COIN TELEPHONE SET—2A-TYPE INSTALLATION AND MAINTENANCE

1.001 This addendum supplements Section 506-328-200, Issue 2.

1.002 This addendum is issued to:

Fig. 12—Coin Chute Assembly

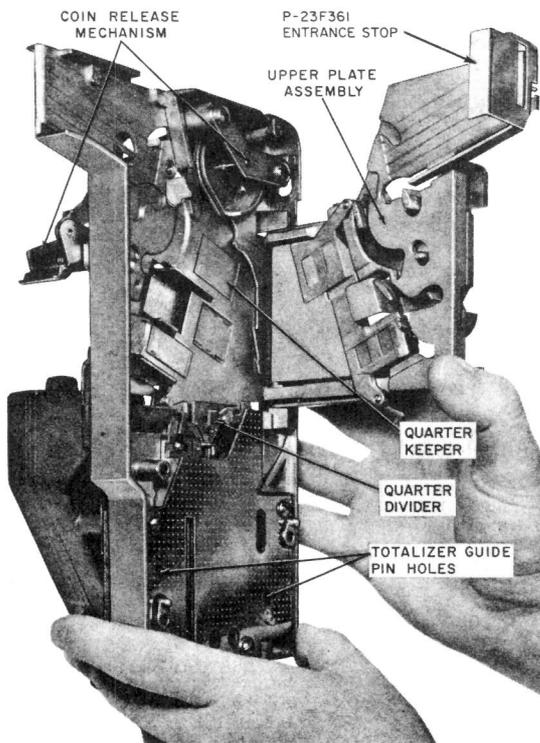
Fig. 12—Revised to show locking tab feature of P23F361 entrance stop.

3.21.1 A P-23F361 entrance stop (Fig. 12 and 13) can be installed on the coin chute to reduce coin chute stuffing. When the coin release lever is operated, the entrance stop moves sideways and closes the coin slot.

Fig. 13—P-23F361 Entrance Stop

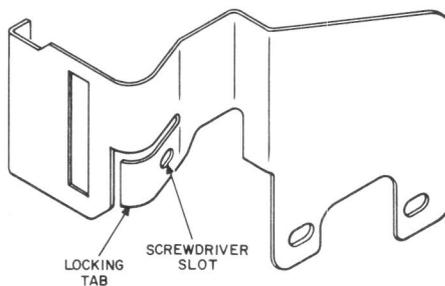
3.21.2 A prefabricated locking tab arrangement on the entrance stop can be bent with a screwdriver (by authorized personnel) to hold the upper plate assembly off-normal (Fig. 13). This will prevent customer coin deposits in newly installed coin telephone sets awaiting initial service connection or those that are out of service which require further maintenance or repair.
